WALTON WATERLINE AND STORAGE TANK PROJECT – PIPELINE ALIGNMENT MODIFICATIONS

Mitigated Negative Declaration Addendum

Prepared for
City of Yuba City

May 2009

Figure 1-1
2008 IS/MND and Revised Pipeline Alignments

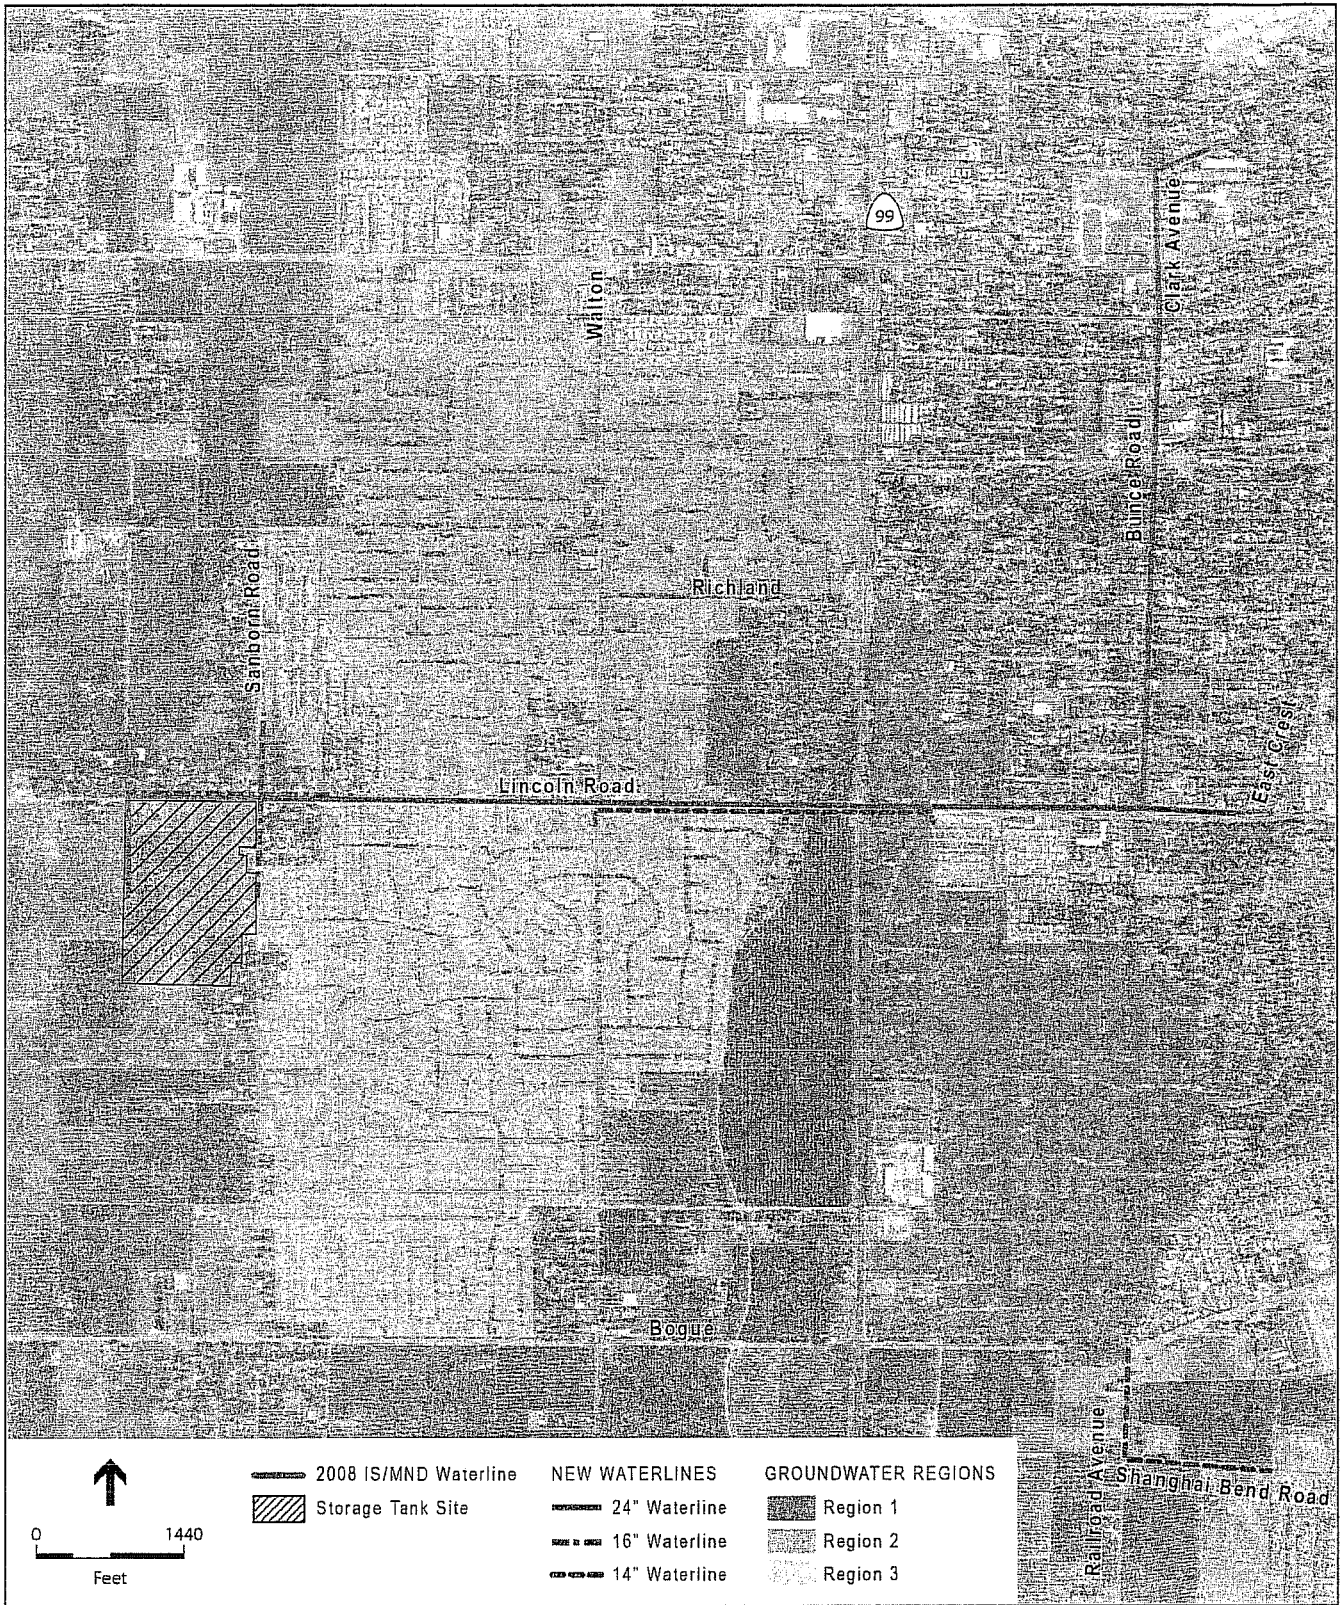
The previous proposed project is analyzed in Section of the 2008 IS/MND. **Figure 1-1** of this Addendum shows the layout of the project components as analyzed in the 2008 MND in addition to the Modified Project facilities. Refer to Section 2.0 of the 2008 IS/MND for a discussion of impacts of the 2008 project in the following areas: Aesthetics, Agriculture Resources, Air Quality, Biological Resources, Cultural Resources, Geology and Soils, Hazards and Hazardous Materials, Hydrology and Water Quality, Land Use and Planning, Mineral Resources, Noise, Population and Housing, Public Services, Recreation, Transportation/Traffic, and Utilities and Service Systems.

In addition to the inclusion of HWS Region 1 into the proposed water service area, the Modified Project would include the addition of a new 14-inch waterline parallel to the proposed 30-inch main on Lincoln Road from Phillips Road to Walton Avenue and a new 16-inch waterline along Lincoln Road from the vicinity of Krentz Lane to Ohleyer Road. Waterlines outside of the previous IS/MND study area include a new 16-inch waterline north and south of Lincoln Road on Sanborn Road in the vicinity of the proposed storage tank site, a 24-inch line on Lincoln Road from Bunce Road to Eastcrest Court, and a 14-inch waterline from Shanghai Bend Road west to Railroad Ave and north to Bogue Road (**Figure 1-1**). All proposed improvements associated with the Modified Project would be located within existing right-of-ways.
